**Request for Additional Information No. 306, Question 03.08.01-39, Revision 1**

**U.S. EPR Standard Design Certification**

**Docket No. 52-020**

**Question 03.08.01-39:**

**Figure 03.08.01-39-1—Plot of Additional Thermal Demand against the Interaction Diagrams for Containment Wall Section**

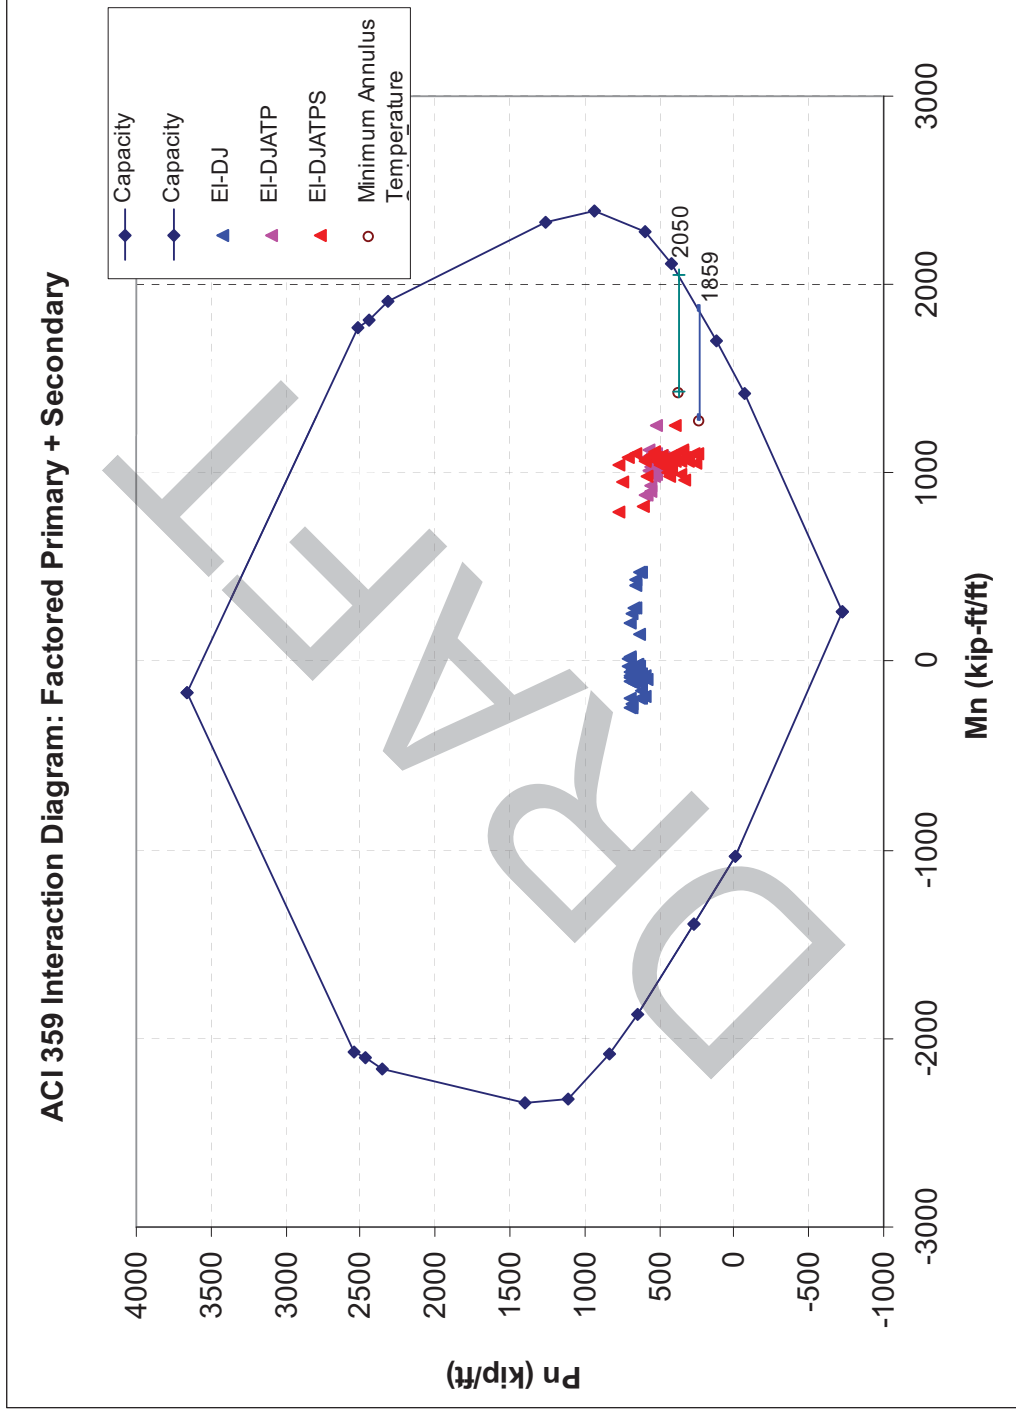
5. The response to RAI Number 3.8.1-14 states that the axisymmetric model of the RCB was also used to study the effect of the variations in the temperature of the annulus relative to the 79F value used to date, and that the results of this study would be given in the response to this RAI. Since the RAI response only marginally mentions this issue, provide a complete discussion on the results of this study.

Figure 03.08.01-44-4(a), in the Response to RAI 335, Question 3.8.1-44, shows the additional capacity of the containment wall against the demand. Table 03.08.01-39-3 shows that the

maximum thermal moment of 185 kip-ft/ft, along with the tensile axial force of 17 kip/ft, represents the worst case scenario for the additional thermal moment due to minimum annulus temperature (45°F). The extra thermal force and moments are added to the existing demand and plotted against the RCB wall capacity interaction diagrams in Figure 03.08.01-39-1. Figure 03.08.01-39-1 shows that there is sufficient section capacity (615 (=2050-1435) kip-ft/ft or 573 (=1859-1286) kip-ft/ft) in the wall at the 45°F minimum annulus temperature. Therefore, design capacity shown in Figure 03.08.01-39-1 adequately envelopes the additional demand for the unlikely scenario of a 45°F minimum annulus temperature.

Figure 03.08.01-39-1 is based on the current critical section design. The margin shown in Figure 03.08.01-39-1 is not expected to vary significantly from the final critical section design. The final response to RAI 155, Question 3.8.4-6 will include confirmation that sufficient margin is provided.
